Crowchild Trail Study

Phase 4 - Online Engagement Summary June 2016

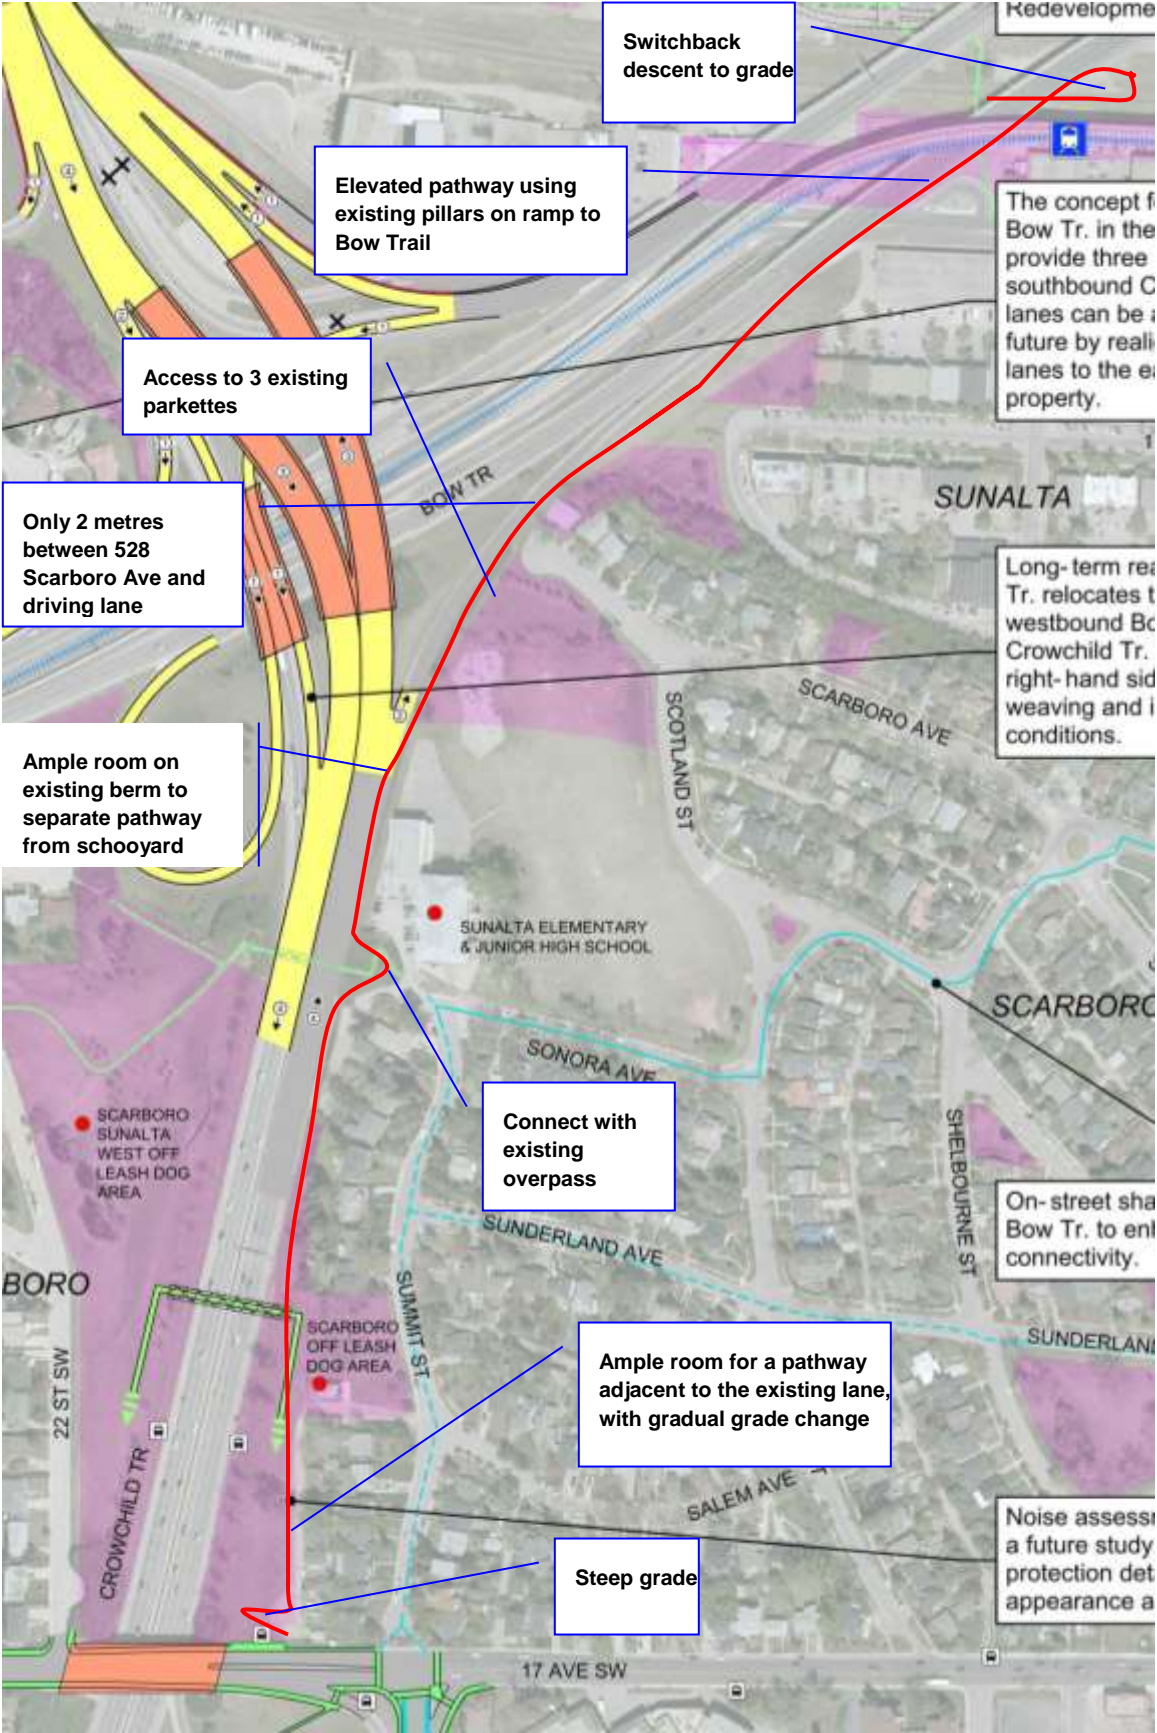
- (3) From the conceptual drawing it looks like it is contemplated that people heading east on 16th Avenue NW will have to go through a traffic light to access Crowchild Trail north. That concept does not take into account the big picture of accommodating traffic going through the Sarcee Trail & 16th Avenue NW and Shaganappi Trail & 16th Avenue intersections wanting to go to the near NW. To me, an expressway from Sarcee & 16th to Crowchild & 16th with appropriate interchanges on 16th at Sarcee, Shaganappi, and Crowchild makes a lot of sense. Given the elevations and space to work with in the immediate of area Crowchild and 16th, it should not be exceptionally difficult to build ramps that allow traffic without traffic lights to, heading south on Crowchild to go any of three directions, east, west, or south, heading east on 16th to go north, south, or east, or heading west on 16th to go north, west, or south. An expressway through Montgomery with a service road and interchange access at around the Shaganappi intersection/interchange would not be that disruptive, just removing some service stations, strip malls, and [omitted] hotels. And service roads could be configured so that the Foothills Medical Centre, the proposed development on the Stadium Shopping centre, and 29 Street traffic uses the existing overpass northwest of the medical centre to access 16th avenue.

- Attached are a couple of sketches illustrating what makes sense to me. Oh, and by the way, some of the concepts utilize traffic circles. For many situations they are far more preferable to intersections controlled by traffic lights. About a decade ago spent some time in the UK on a North Sea project, and after getting accustomed to them learned to prefer them over traffic lights.
